City of San Antonio
TRANSPORTATION AND CAPITAL IMPROVEMENTS

ADDENDUM NO. 4

PROJECT NAME: **Ray Ellison (Loop 410 to Old Pearsall Road)**

PROJECT NO.: **40-00312**

100 % SUBMITTAL	PROJECT NO.: 8185-00		DATE: 3/24/2015
DRWN. BY: HM	DSGN. BY: HM	CHKD. BY: DT	SHEET NO.: 43

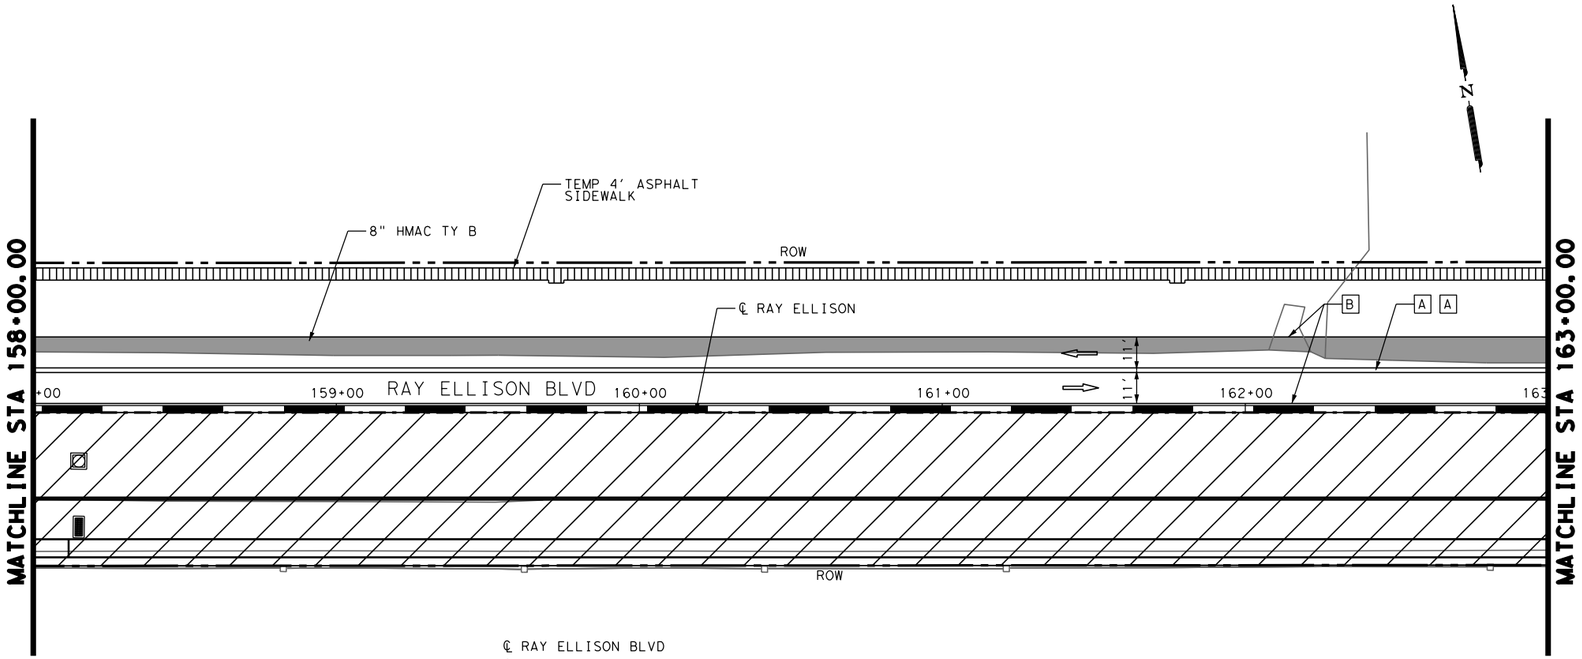
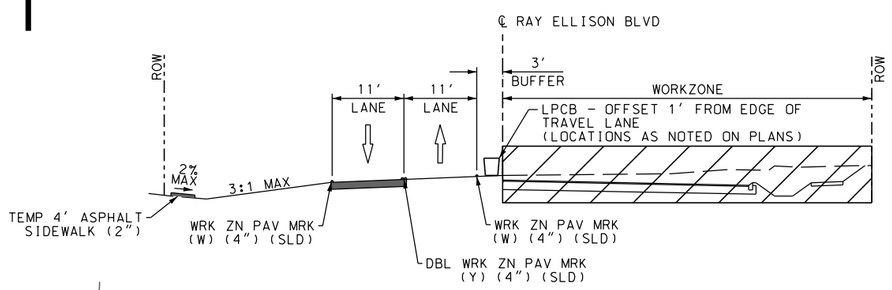
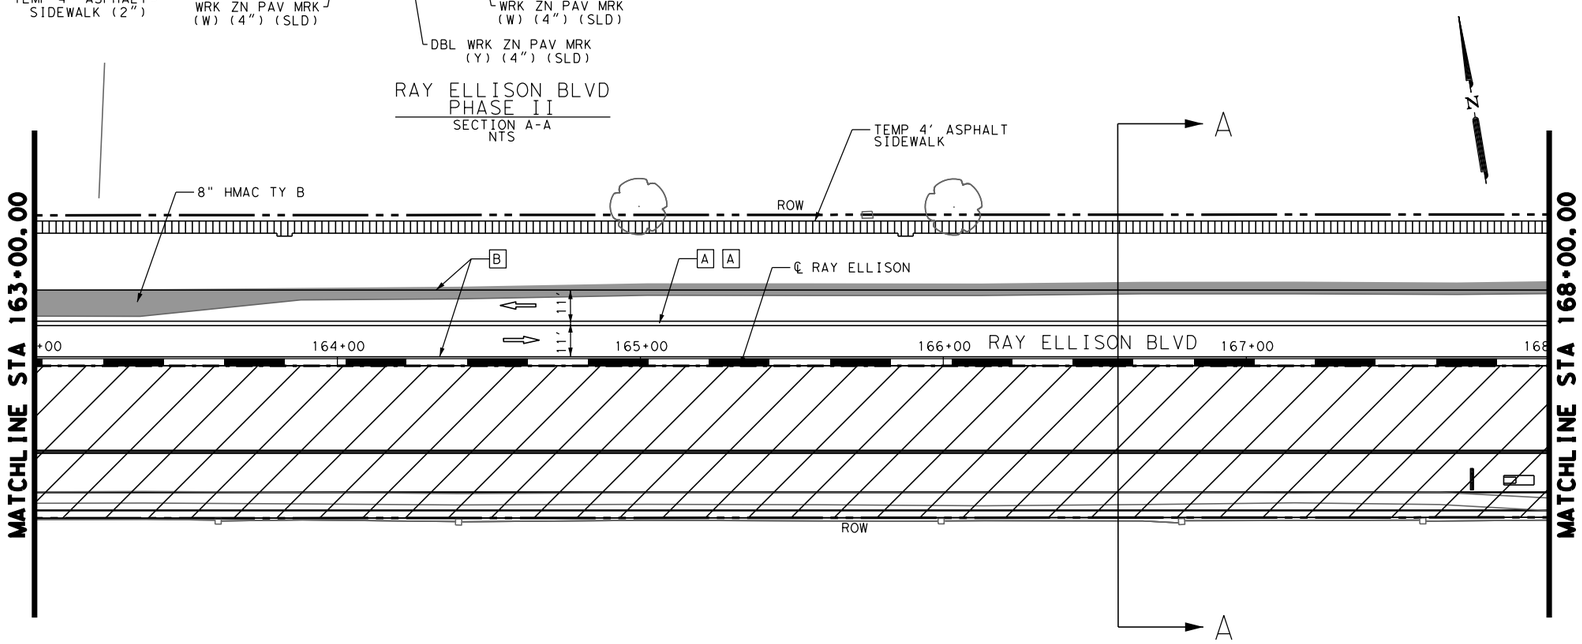
- Replace Sheet 42 “Traffic Control Plan Layout Phase 2” with Addendum No. 4 Sheet 42 “Traffic Control Plan Layout Phase 2” Revised typical section.
- Replace Sheet 43 “Traffic Control Plan Layout Phase 2” with Addendum No. 4 Sheet 43 “Traffic Control Plan Layout Phase 2” Revised typical section.

17. TCP Phase II sheets show a 4" temporary sidewalk in the cross section, yet calls out a 2" depth in the legend. Which depth is correct?

Response: All temporary sidewalks will have 2" depth. TCP sheets are revised for Addendum 04.

100 % SUBMITTAL	PROJECT NO.: 8185-00		DATE: 3242015
DRWN. BY: HM	DSGN. BY: HM	CHKD. BY: DT	SHEET NO.: 56

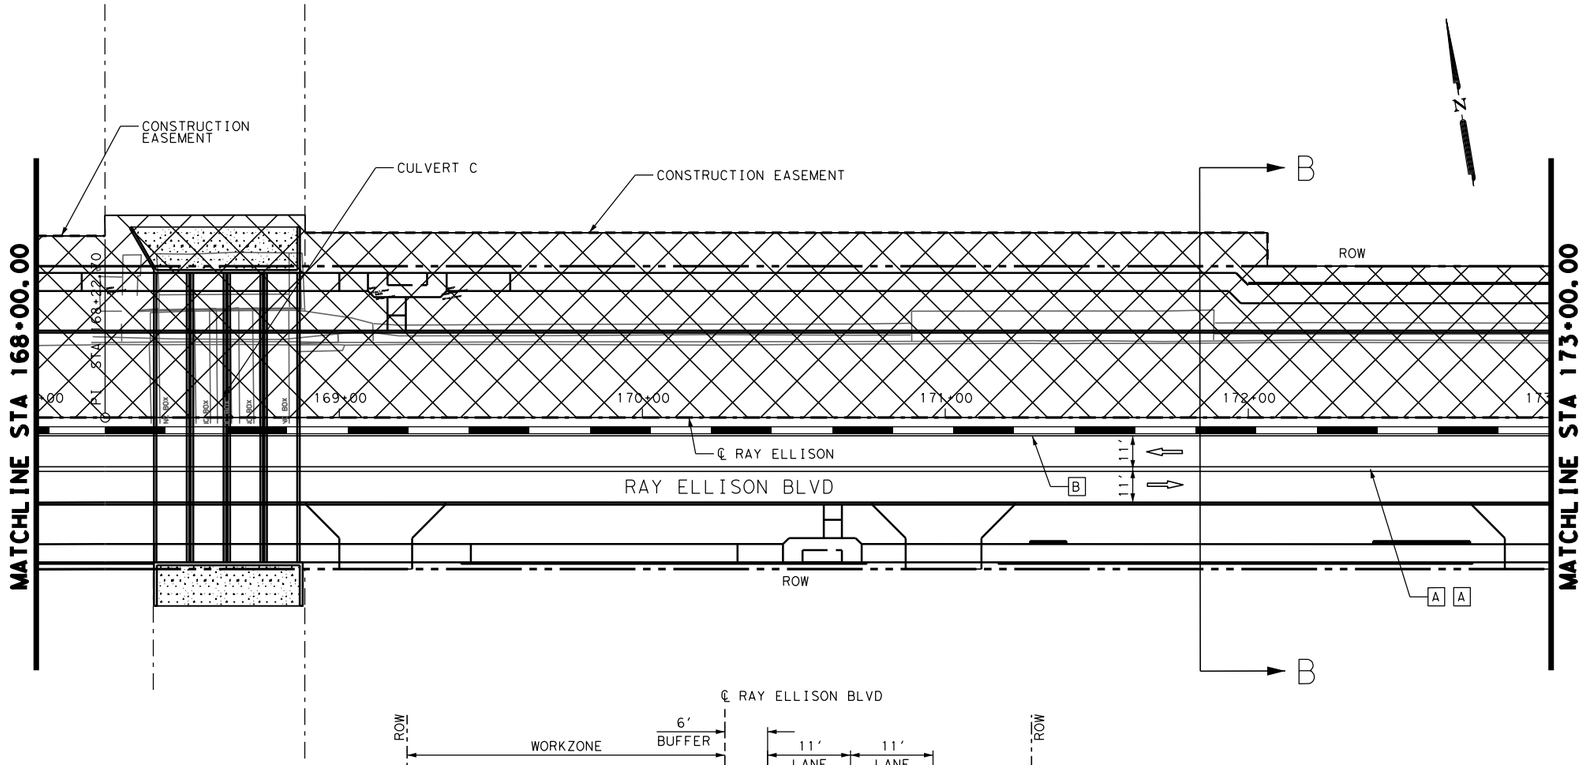
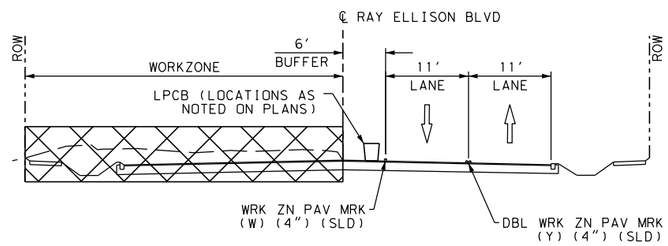
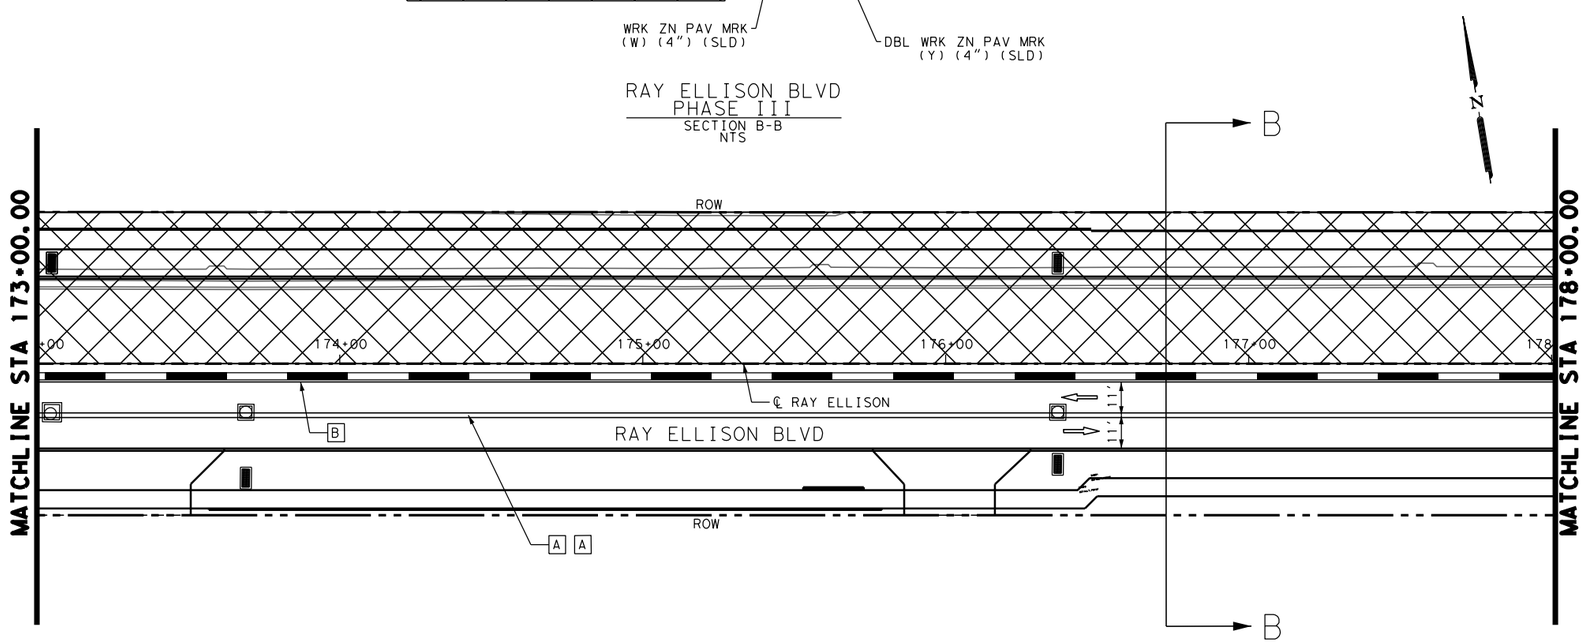
- Replace Sheet 56 “Traffic Control Plan Layout Phase 3” with Addendum No. 4 Sheet 56 “Traffic Control Plan Layout Phase 3” Revised roadway.
- Replace Sheet 105 “Roadway Plan & Profile Sheet STA 168+00 To STA 173+00” with Addendum No. 4 Sheet 105 “Roadway Plan & Profile Sheet STA 168+00 To STA 173+00” Revised retaining wall and sidewalk.

ROADWAY PLAN & PROFILE SHEET
STA 173+00.00 TO STA 178+00.00
SHEET 16 OF 20

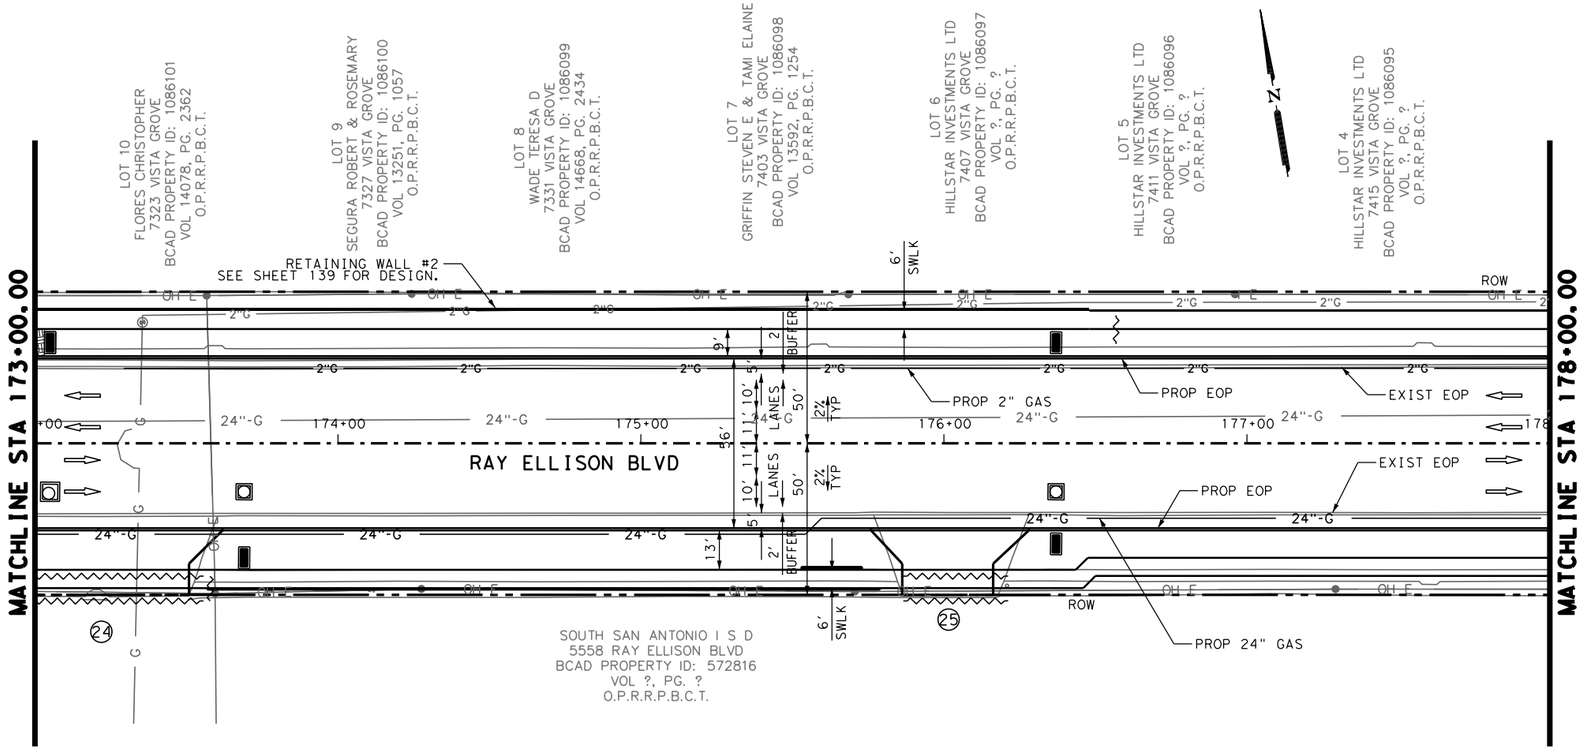
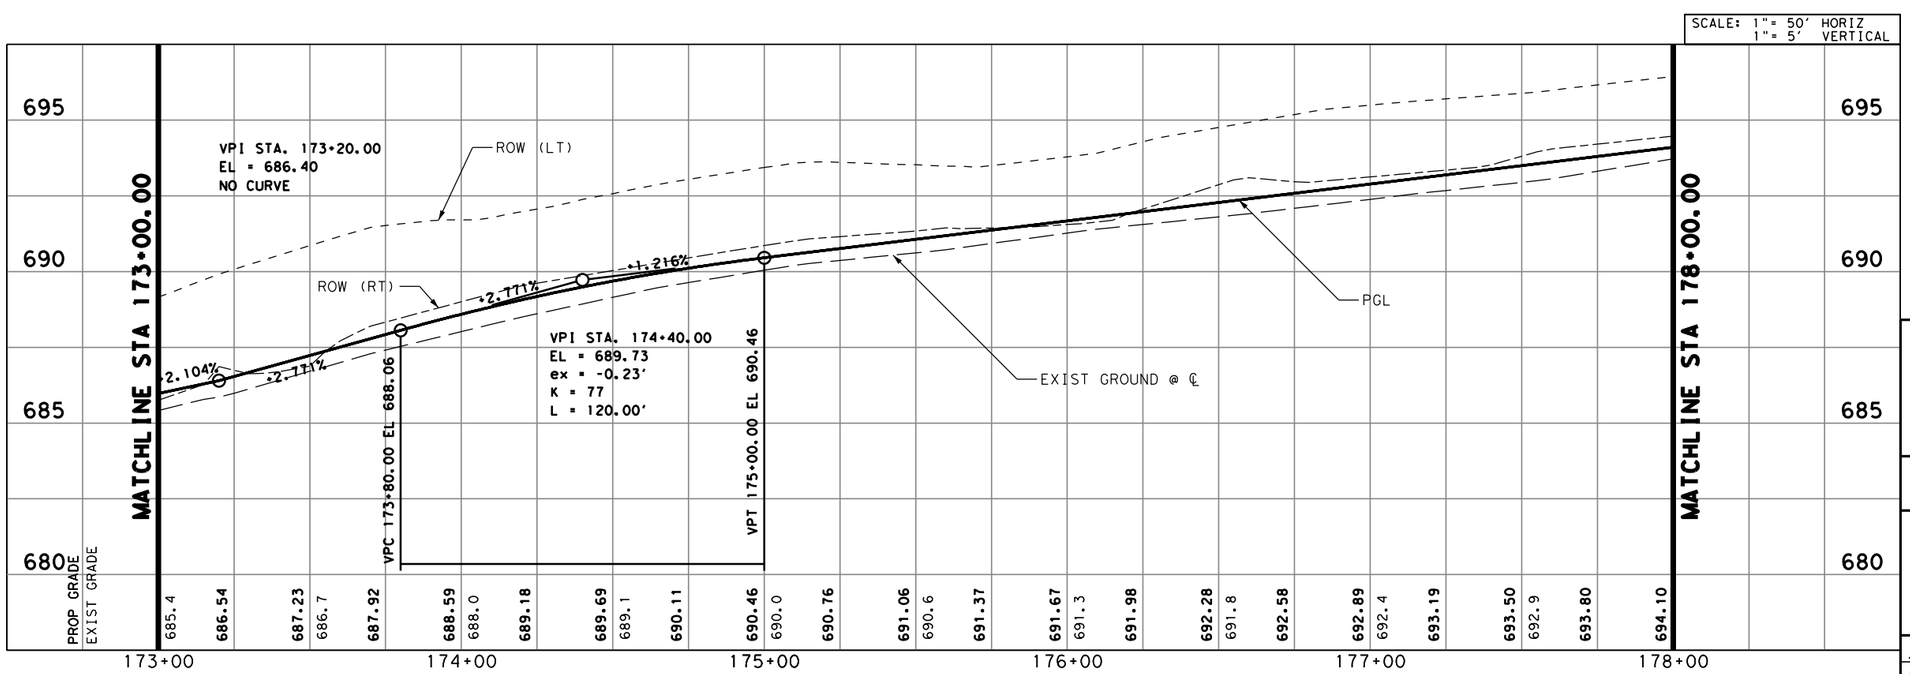
- Replace Sheet 106 “Roadway Plan & Profile Sheet STA 173+00 To STA 178+00” with Addendum No. 4 Sheet 106 “Roadway Plan & Profile Sheet STA 173+00 To STA 178+00” Revised retaining wall and sidewalk.

Response: No additional easements will be provided. Retaining wall and sidewalk are revised per Addendum 4.

100 % SUBMITTAL	PROJECT NO.: 8185-00		DATE: 3/24/2015
DRWN. BY: JS	DSGN. BY: HM	CHKD. BY: DT	SHEET NO.: 121

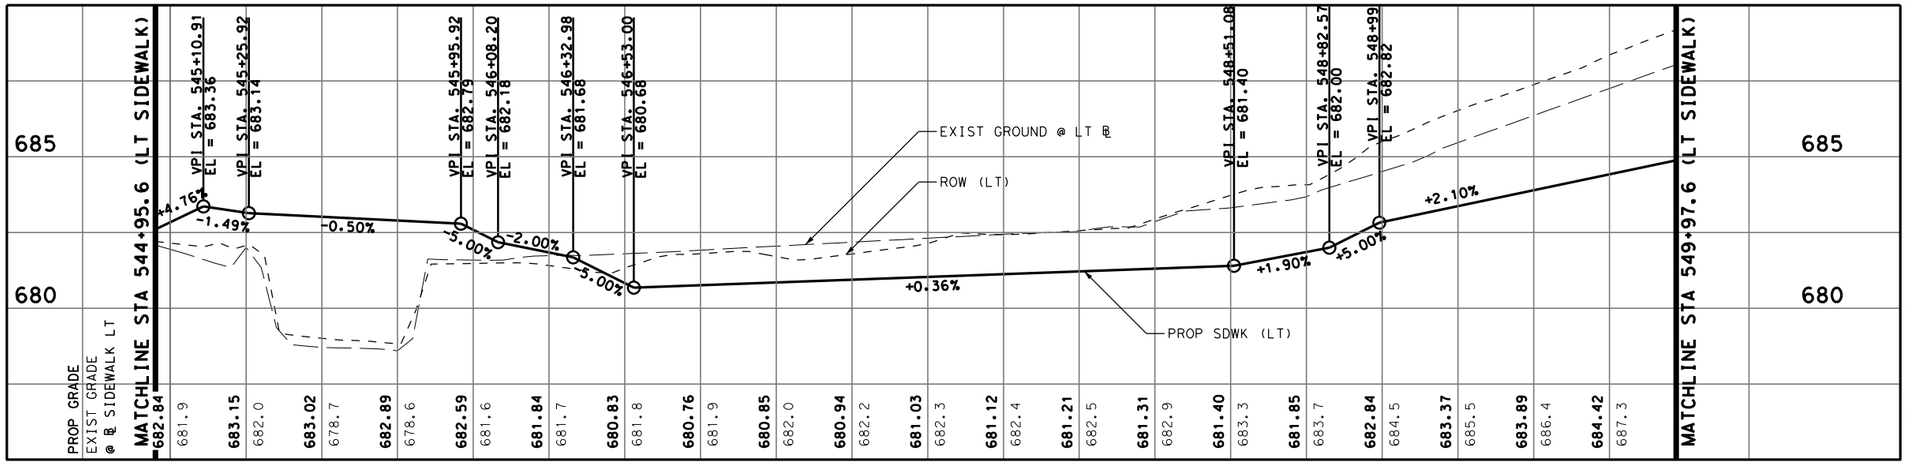
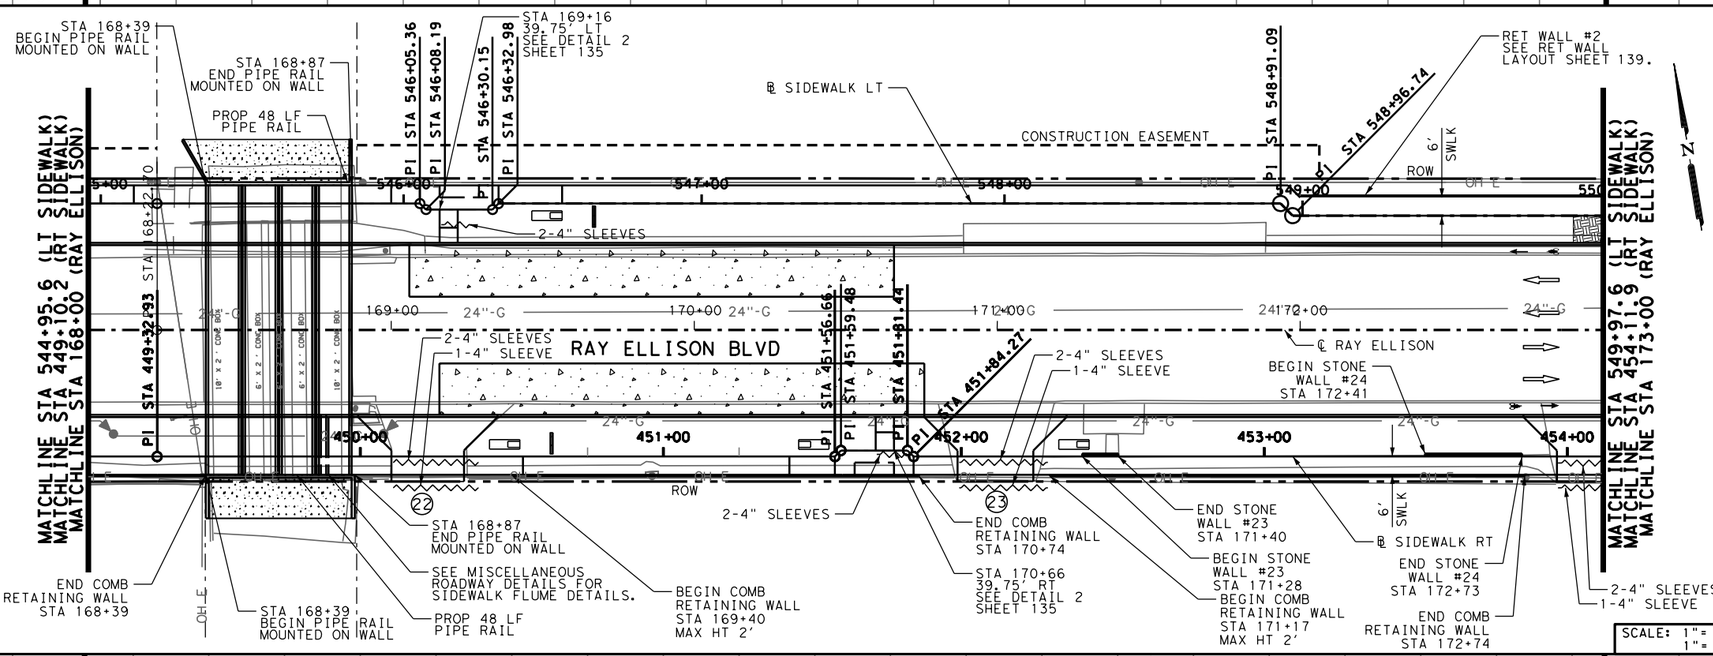
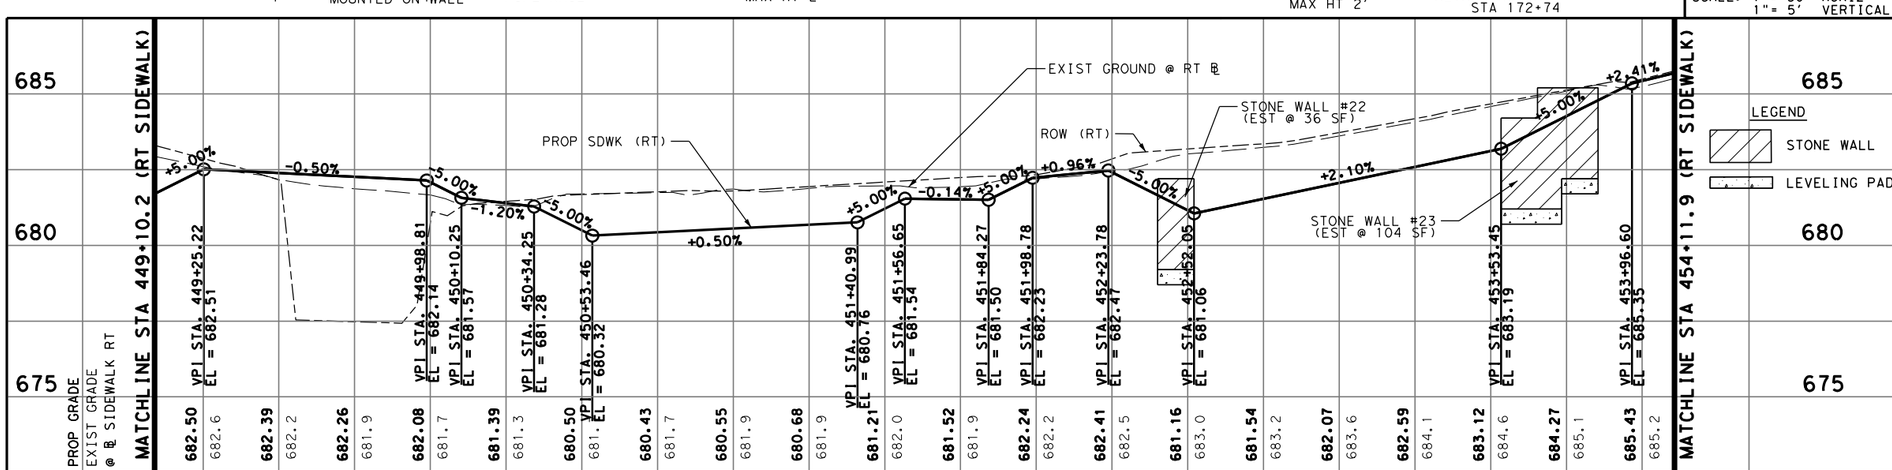
- Replace Sheet 121 “Sidewalk Plan & Profile Sheet STA 168+00 To STA 173+00” with Addendum No. 4 Sheet 121 “Sidewalk Plan & Profile Sheet STA 168+00 To STA 173+00” Revised retaining wall and sidewalk.
